Coughlan Consulting Engineering

22020

SD21B/0619 - Additional Information for 66, Wainsfort Road, Terenure, Dublin 6W – Conditions 4 and 5

CCE
66 WAINSFORD ROAD
SK01
APRIL'22

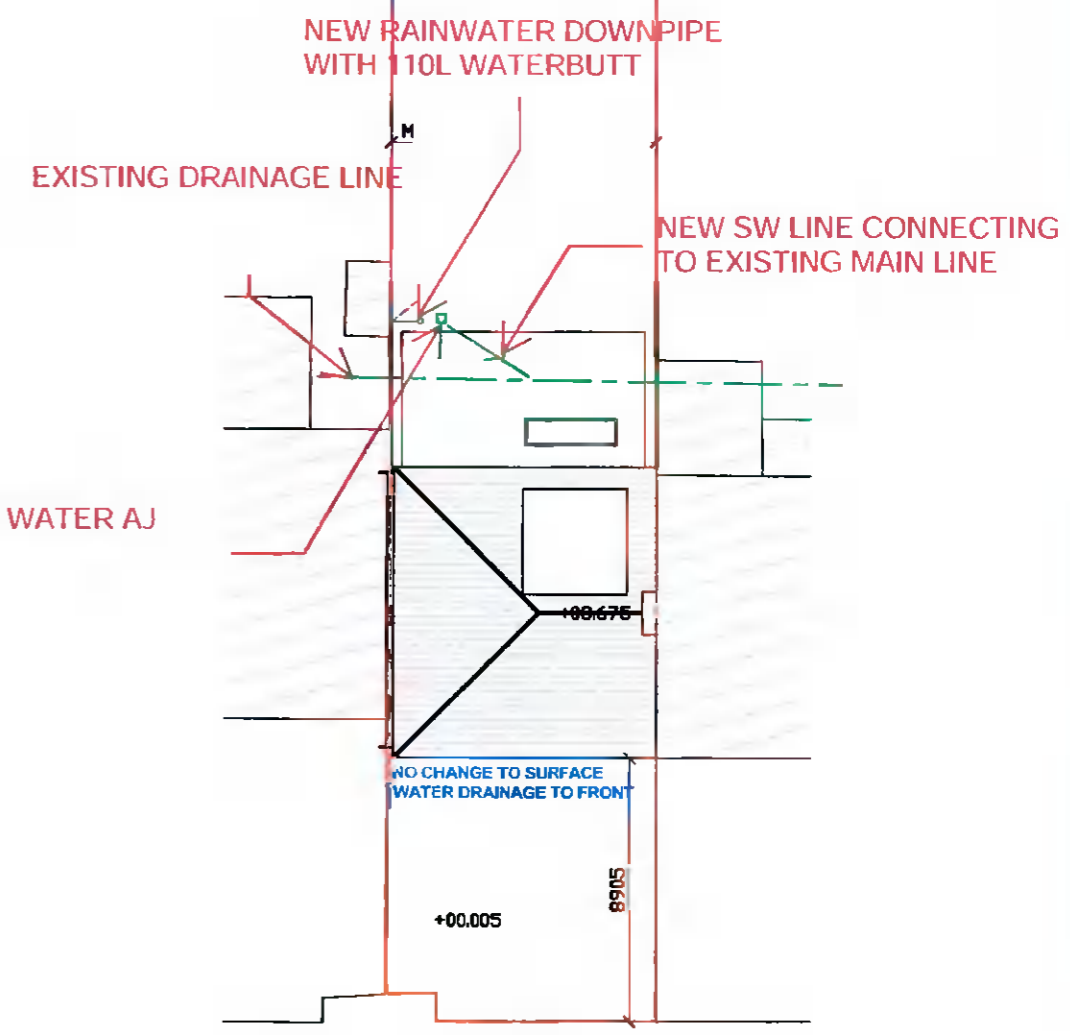
Item 4. There are no soil percolation test results, design calculations or dimensions submitted for the proposed soakaway. The applicant is requested to submit a report showing site specific soil percolation test results and design calculations for the proposed soakaway in accordance with BRE Digest 365 – Soakaway Design. Should a soakaway prove not to be feasible, then the applicant shall submit A revised surface water layout drainage drawing for the development showing the inclusion of the following SuDS (Sustainable Drainage Systems) features.

Item 5. The applicant is required to submit a revised drawing showing plan & cross-sectional views, dimensions, and location of proposed soakaway. Any proposed soakaway shall be located fully within the curtilage of the property and shall be: i) At least 5m from any building, public sewer, road boundary or structure. ii) Generally, not within 3m of the boundary of the adjoining property. iii) Not in such a position that the ground below foundations is likely to be adversely affected. iv) 10m from any sewage treatment percolation area and from any watercourse / floodplain. v) Soakaways must include an overflow connection to the surface water drainage network

Coughlan Consulting Engineering instructed an infiltration test on site to determine the required size for the soakaway test and the test water stood for over 24 hours without any significant drop. Based on this Coughlan Consulting Engineering can confirm that a Soakaway will not be suitable on this site.

It is noted that there is an ancillary and playroom to the rear of the dwelling currently. It is proposed to demolish these structures which is circa 24m² and construct a new rear single storey extension which will be circa 33m². The net new hardstanding area is circa 9m². It is proposed to introduce a new 110l Waterbutt onto the new rainwater downpipe on the rear extension. This waterbutt will collect rainwater runoff and can be used to water gardens etc. This waterbutt will discharge into a new gully and into new separate SW line in the back garden before connecting to the existing main drainage line.

Please see CCE-SK01 attached.
